IBC — Structural

2021 GROUP A PROPOSED CHANGES TO THE I-CODES

April 11 – May 5, 2021
Virtual Committee Action Hearings

S10-21

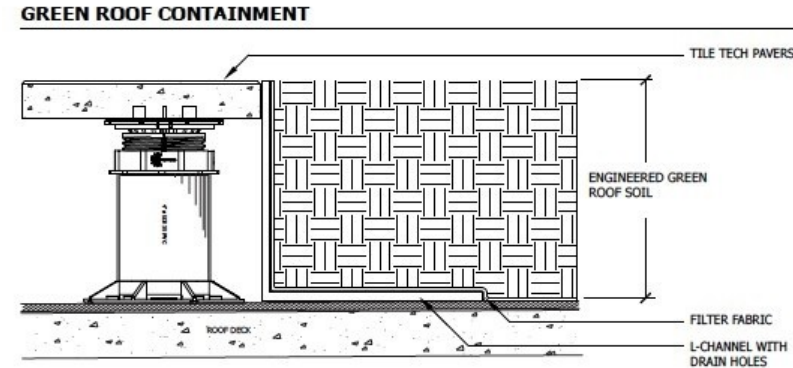
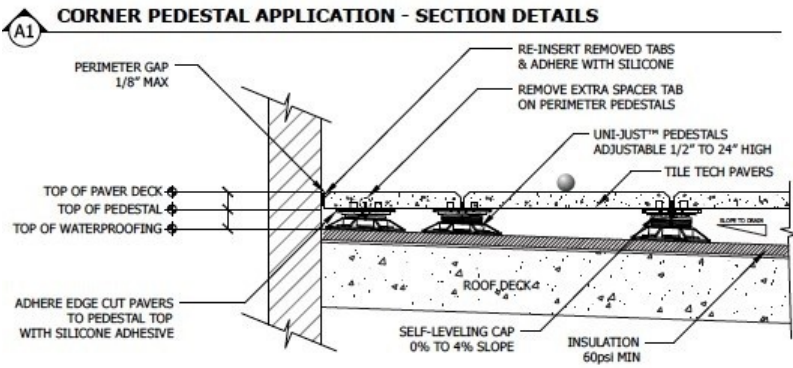
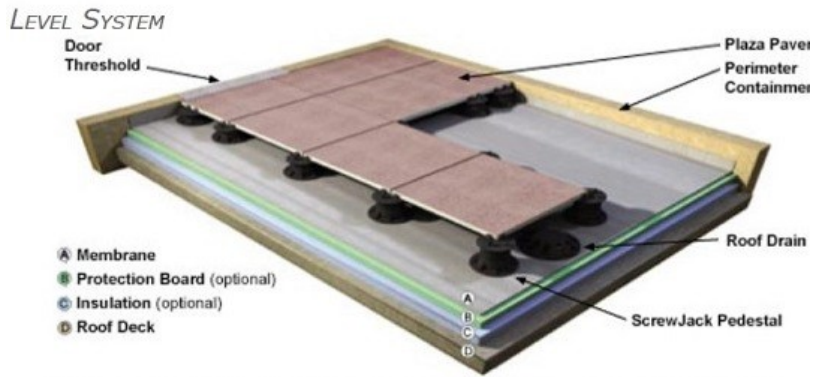
1511.9 Raised-deck systems installed over a roof assembly. *Raised-deck systems* installed above a *roof assembly* shall comply with Sections 1511.9.1 through 1511.9.5.

1511.9.1 Installation. The installation of a *raised-deck system* shall comply with all of the following:

1. The perimeter of the *raised-deck system* shall be surrounded on all sides by parapet walls or by a noncombustible enclosure approved to prevent fire intrusion below the *raised-deck system*. The parapet wall or enclosure shall extend above the plane of the top surface of the *raised deck system*.
2. A *raised-deck system* shall be installed above a listed roof assembly.

1511.9.2 Fire classification. The *raised-deck system* shall be tested, listed and labeled with a fire classification in accordance with Section 1505. The fire classification of the *raised deck system* shall be not less than the fire classification for the *roof covering* over which it is installed.

1511.9.4 Structural requirements. The *raised-deck system* shall be designed for wind loads in accordance with Chapter 16 and Section 1504.5. The *raised-deck system* shall be designed for seismic loads in accordance with Chapter 16.

1511.9.5 Roof drainage. The *raised-deck system* shall not impede the operation of the roof drainage system as required by Section 1502 and the *International Plumbing Code*.

Reason Statement: Currently the IBC does not have any specific provisions for the design and installation of raised-deck systems. These provisions should be a subsection to Section 1511 because these systems are a roof structure over a roof assembly. A definition of "raised deck systems" is needed to ensure correct application of new requirements for these systems. This term is applicable only to Chapter 15 (same "Chapter 15 restriction" as the definition for roof assembly).

Fire test requirements for the raised deck systems are based on research studies performed for PV panels on low and steep-sloped roofs; which have general applicability to Raised Deck Systems. The following is a link to the reports for those studies:

<http://www.solarabcs.org/about/publications/reports/flammability-testing/index.html>. These studies showed that when fire was able to enter the space between the roof assembly and the panel above, it could significantly alter the original test results for the fire classification of the roof assembly. By providing a protective barrier at the perimeter such as a parapet wall, roof curb or intersection with vegetative roof to prevent fire intrusion into the space, there would not be any concern with affects to the fire classification of the roof assembly underneath.

Three pointers (code references) for structural; roof water drainage; and access and egress are provided to ensure that these other safety and performance requirements essential for roofs are applied to Raised Deck Systems. The pictures included with this code change illustrate examples

of what a typical raised deck system consists of, including a photograph of an actual rooftop pool deck, two cross-sections of a typical raised deck system, and an isometric view of the typical components.
